Rig- Aban VI
Auditor- Dr Omar Thakur – Regional QHSE Manager

Purpose-

The purpose of the audit was to highlight general safety related issues, deficiencies and requirements as an assessment of the rigs compliance with Aban’s Management System and general safety standards. An attempt has been made to suggest changes along with the appropriate ordering information for each finding, so that it is easy for each department to order the equipment needed. Some of the suggestions are as per general safety standards upheld by most major oil companies worldwide. It is my strong recommendation that as a company we should strive to achieve a higher safety standard by going above and beyond just the minimum standards required especially when it comes to QHS & E issues relating to our daily activities.

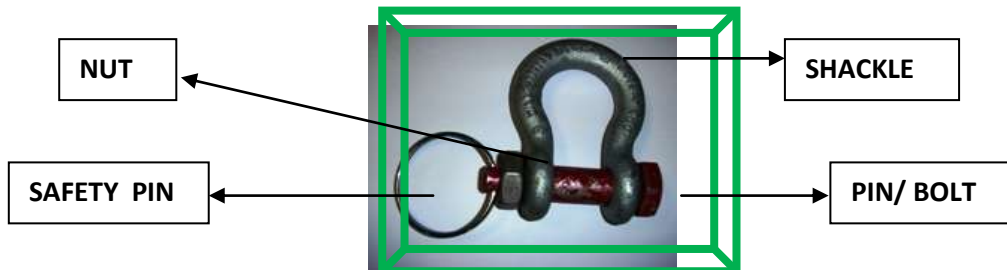
A log book should be maintained for logging all equipment/ tools before going into the derrick. This log was not available to the auditor before going up the derrick. Rig should strictly look into maintaining this log as per section 5.6a of policy SAF 500.00.

Drillers and assistant drillers to ensure this is done at all times and tool pushers to frequently monitor and audit this requirement.

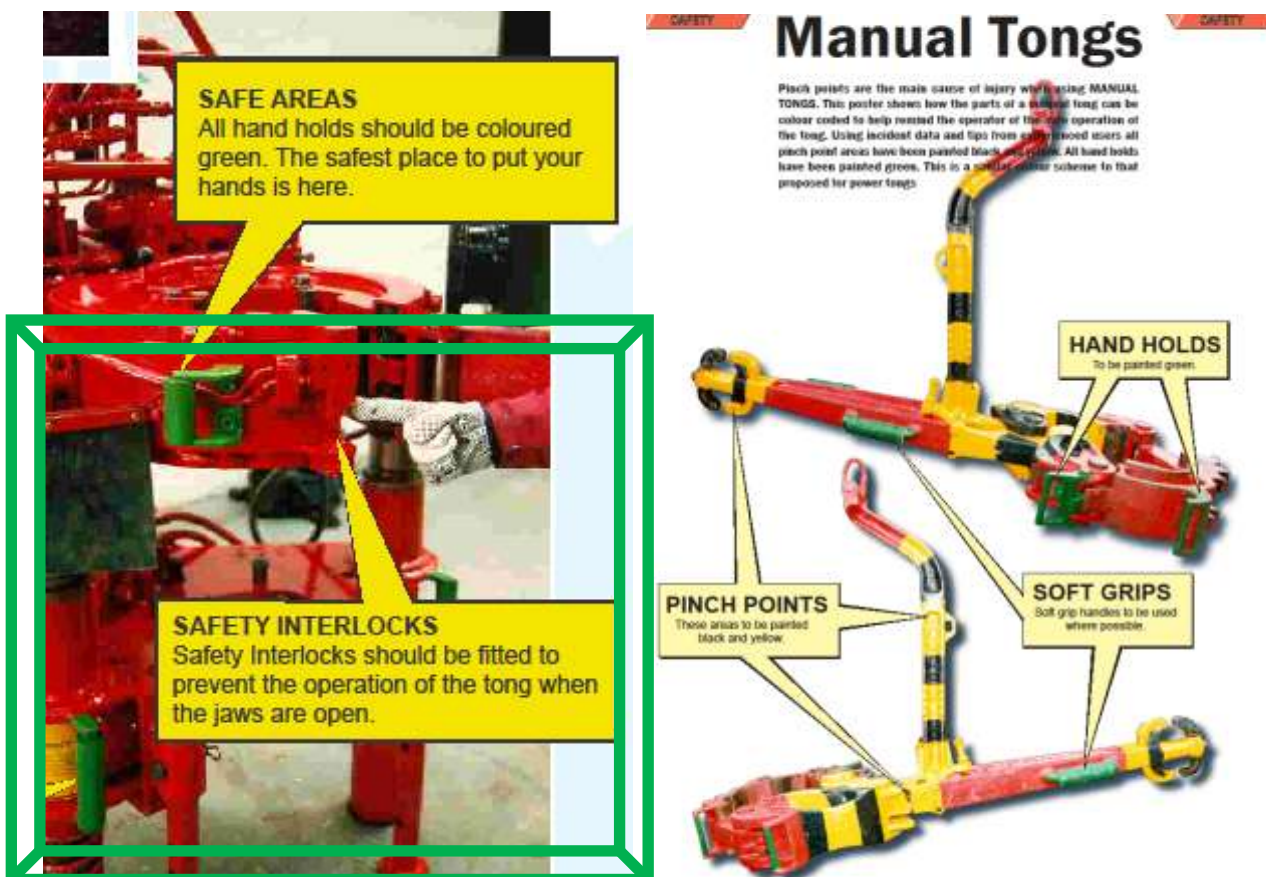
Currently there is one man riding winch available on the rig floor but no man-riding winch available for operations below the rig floor. There is also no designated equipment in use for the man riding operations. The rig is using a two part shackle for man-riding operations. The following is suggested to the rig. Man riding winches to be color coded (LG inspection), identified as “For man Riding Only” and marked with SWL i.e 330lbs / 150kg. All equipment relating to man-riding operations must be used and stored separately. Utility winches are not to be used for man-riding

The four part shackle is to be used with ALL FOUR components.

The **3/4” (4.75t) Crosby G-2130 bolt-type shackle** along with the retaining **key ring i.e. McMaster Carr part number 90177A225**. The key ring is easy to use, cost effective and does not easily get knocked out of the slot. It can be easily changed out when needed.

This is the recommended combination for man-riding to be used when using the man-riding winch. This shackle and other man-riding equipment should be used only for man-riding and stored separately. The drilling supervisors should ensure that this equipment is ordered in adequate quantity.

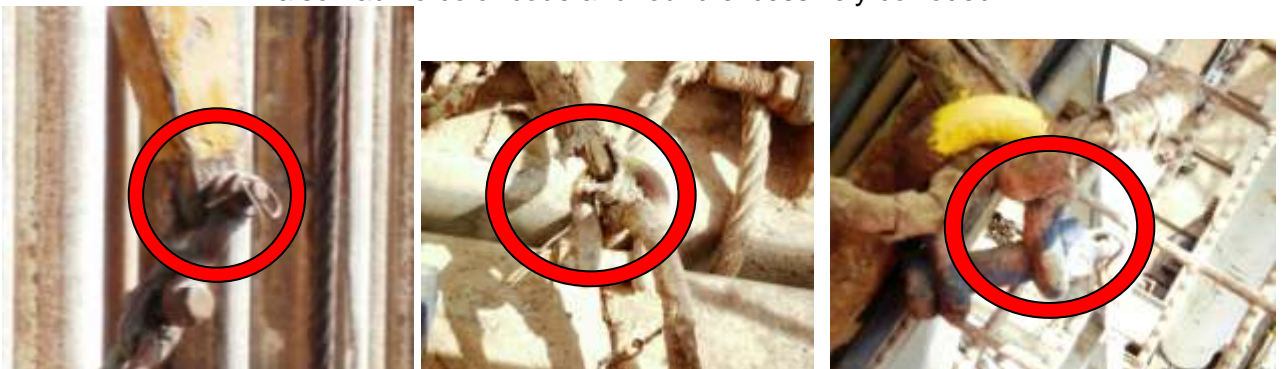
4- Many TWO-Part shackles were evidenced in use on the rig floor and some areas of the derrick. It has become a standard practice for most companies now to do away with all 2-part (screw-pin) shackles in the derrick and overhead areas. These are unsafe to use in permanent overhead applications as they have a tendency for the pin to back out due to vibration and other stresses on the shackle and pin. The rig needs to ensure that all the shackles on the rig floor and in the derrick are changed over to 4 - part safety shackles. The 4-part shackles should be used with a safety pin

Safety pins to be used for ALL 4-part shackles. Wire / welding rods are not to be used as retaining safety pins. Lifting gear seen here has more than one color code. Some lifting gear in the derrick also had no color code and found excessively corroded.

5- The four part shackles in use should have current color code and proper retaining pins and not welding rods or other wires. Many such 4-part shackles were seen with welding rods / wires used as securing pins.

Cotter pins (properly bent), Air king pins or the above mentioned Mc-master key rings should be used as retaining pins on shackles.

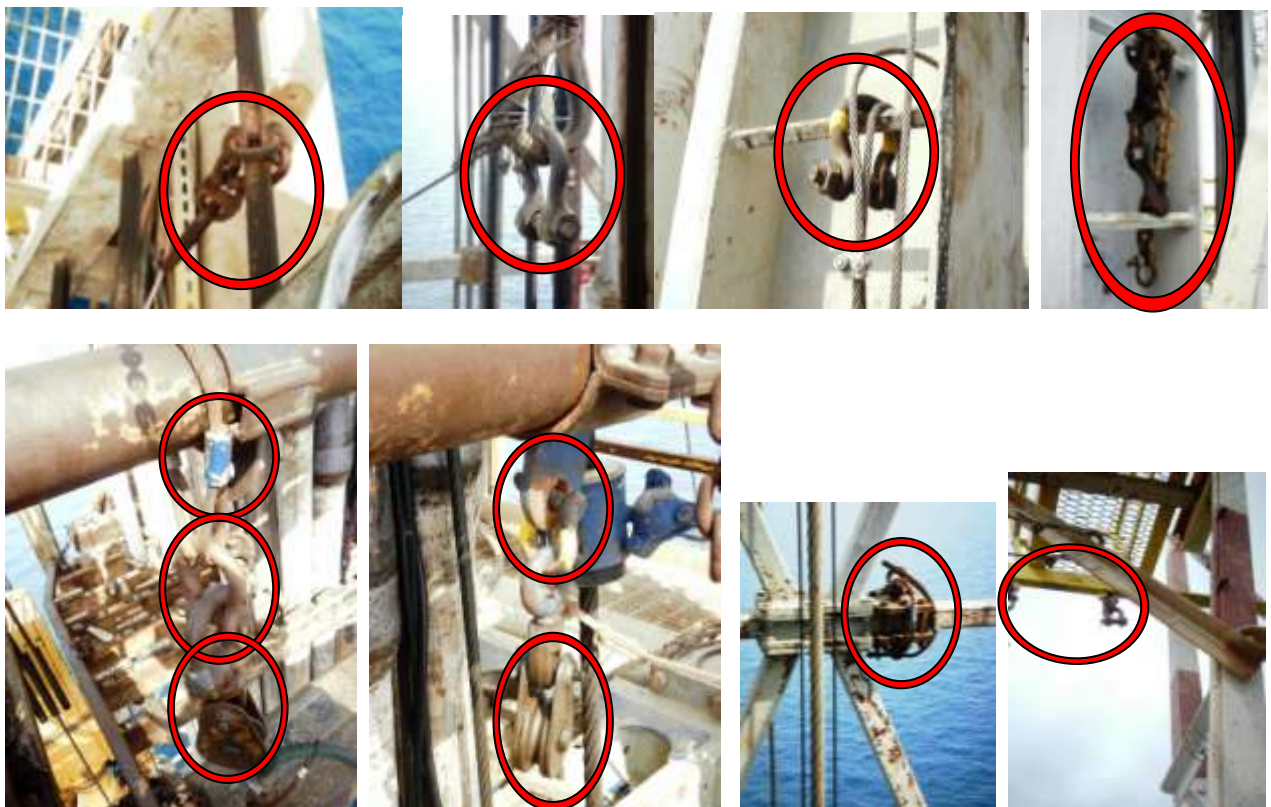
6- The rig should look into changing out old sheaves in the derrick. Certificates and Lifting gear records for this equipment should be maintained along with all other lifting gear.

Safety slings attached to the sheaves are seen rubbing against the slings passing through the sheaves. These should be diverted to avoid damage to either sling.

7- A carabiner was in use at the monkey board as part of lifting gear attachment. This should be removed and only the properly rated shackles should be in use as connectors. Seen above is also derrick-mans SALA with no color coding of block, sling or shackle.

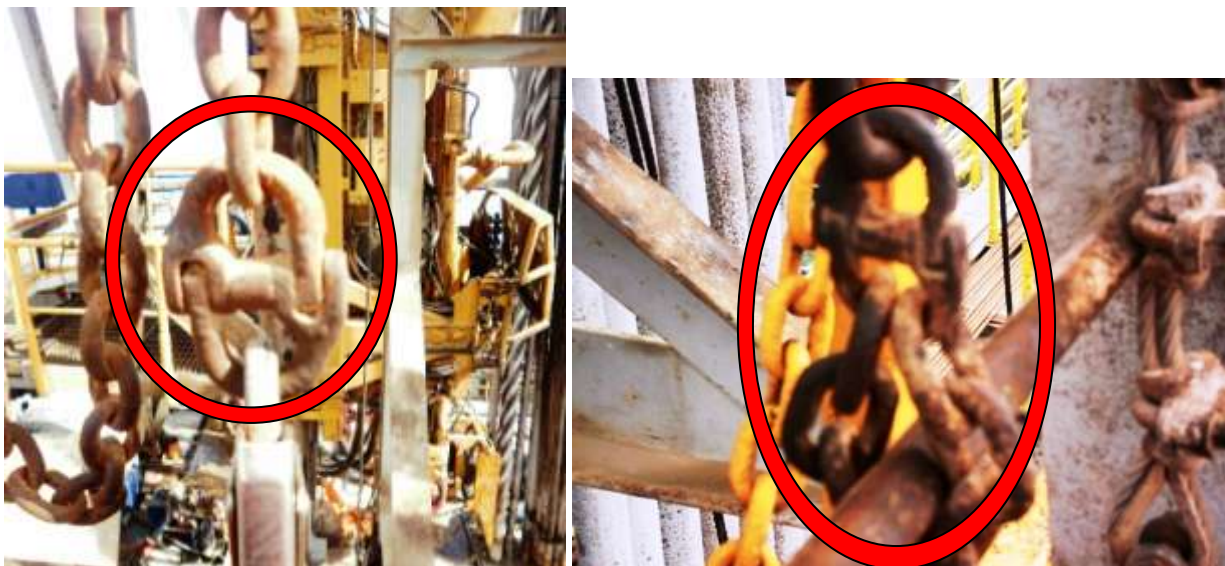
10- Fall protection equipment on Lad-safe device on derrick ladder cable was found heavily rusted and unusable indicating that the lad safe device was not in use. On further questioning it was clear that only the climb assist was in use.

The carabiner shown above on the derrick ladder was heavily rusted and the fall protection device could not be used due to this. An alternate arrangement had to be made to proceed up the derrick using another fall protection device.

The link and chain securing the climb assist to the ladder rung is also old and showing excessive rust. This needs to be changed out immediately.

The rig should order the approved Lad safe device for use as shown in the Safety Catalogue. The equipment should be serviced and maintained on a regular basis.

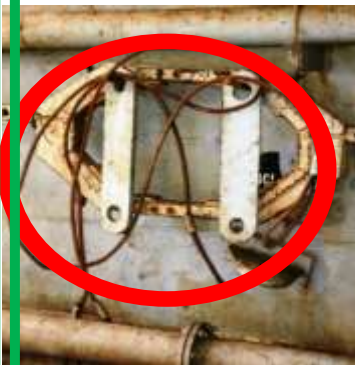
23- Lifting gear color code below deck showed BROWN and BLUE whereas on main deck it showed YELLOW and BLUE. This needs to be standard to avoid any confusion.

Please review Policy SAF 358.00 for lifting Gear and Policy SAF 360.00 for synthetic slings

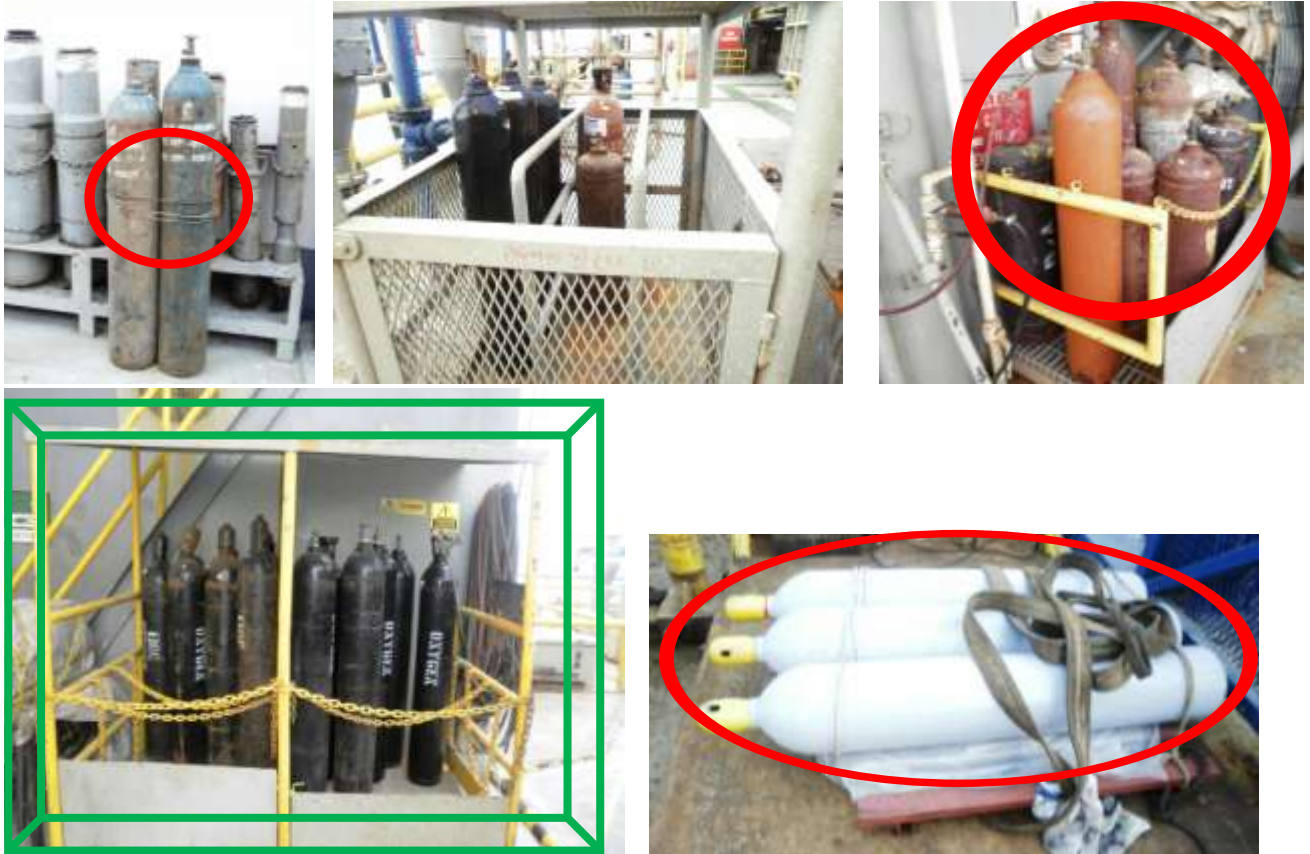
26- Compressed gas cylinders to be transported in proper purpose built racks. They are not to be transported on pallets and other boxes/ containers not designed for safe transportation of compressed gas cylinders.

All compressed gas cylinders to have the contents stenciled on the cylinder. Rope is not to be used as a securing device for cylinders.

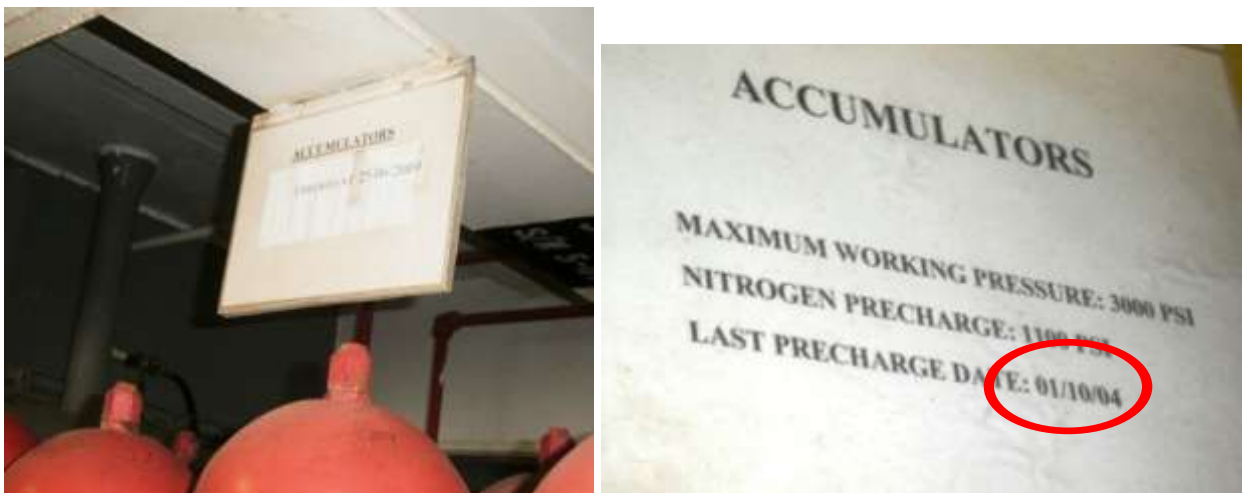
27- Accumulator bottles at the Koomey unit showed an inspection date of 2009 and 2004. Rig was asked to ensure these bottles are inspected / hydro-tested as required.

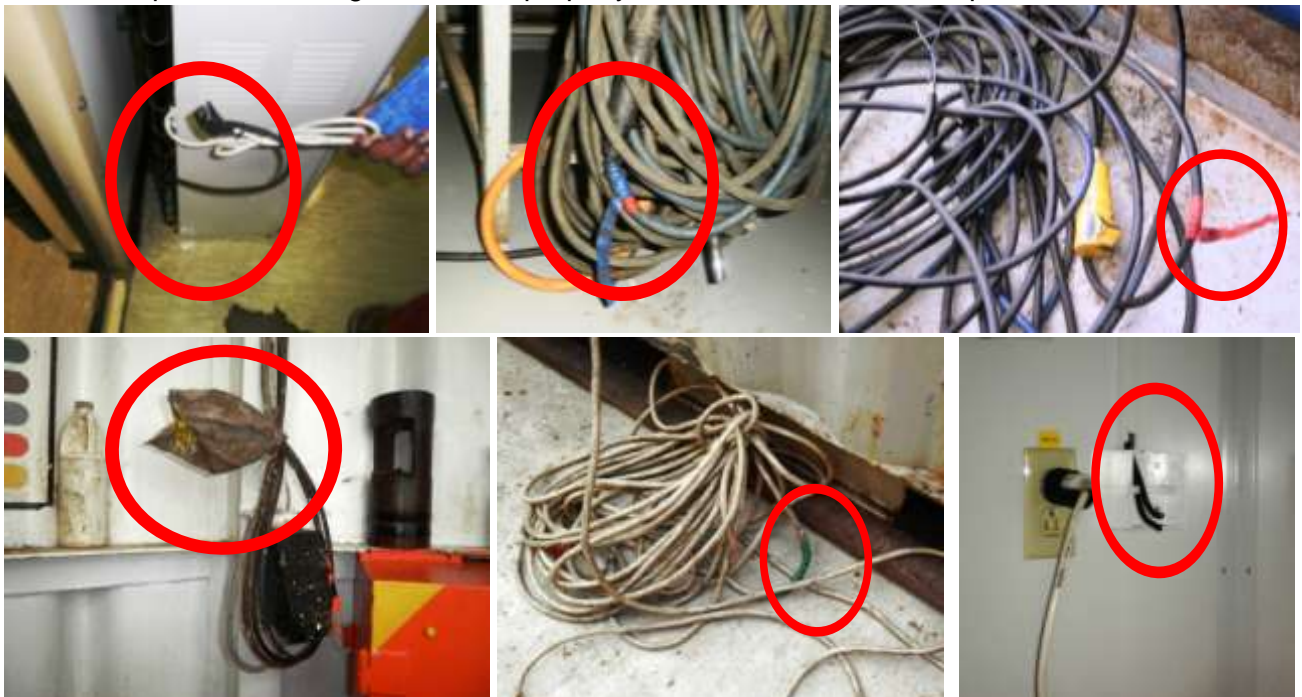
33- Being an old operating rig, many of the electrical cables have cracked insulation and these need to be replaced a.s.a.p. A survey to be done to identify these cables and all to be replaced.

One heavy duty cable running along the starboard side main deck was seen with insulation tape in two places. These damaged/ worn out cables have a serious potential for a hazard as it could lead to electrocution either by contact/ using a pressure washer on deck.

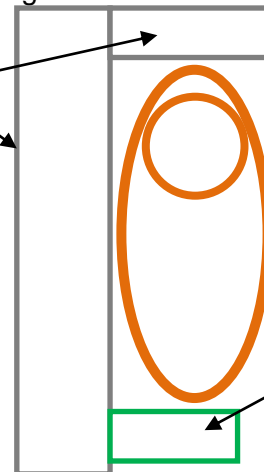
39- Lights at the boat stations were found not working. These are critical for night evacuations and or night personnel transfers if any and should be in working condition with sufficient spares at all times.

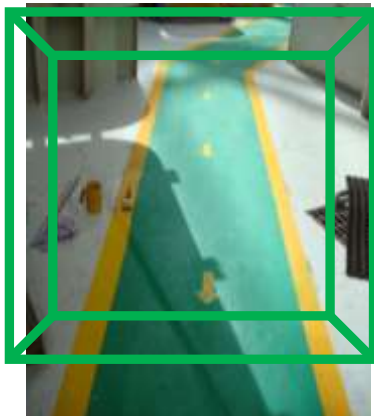
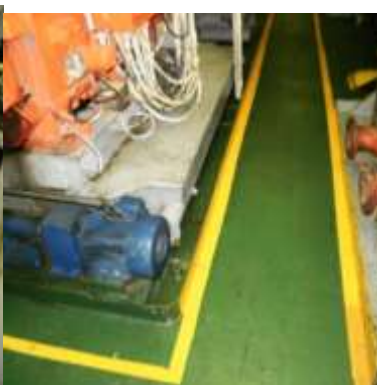
49- Worm clamps are not safe to use and a cause of many incidents and injuries. The rig should use approved “Air king Clamps” with whip checks and safety pins.
